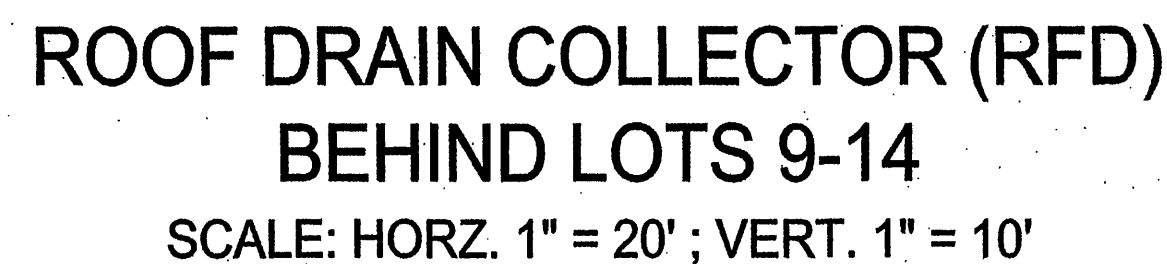
CONTRACTOR MUST
PROVIDE 18" MINIMUM
VERTICAL SEPARATION
BETWEEN WATERLINE AND
ALL STORM AND
SANITARY SEWER.

EXISTING LINE HAS NOT BEEN TESTED OR ACCEPTED BY WVWA. IF THE EXISTING LINE CAN NOT BE UTILIZED, THE CONTRACTOR MUST TAP TO EXISTING WATERLINE IN FLORA FARM DRIVE.
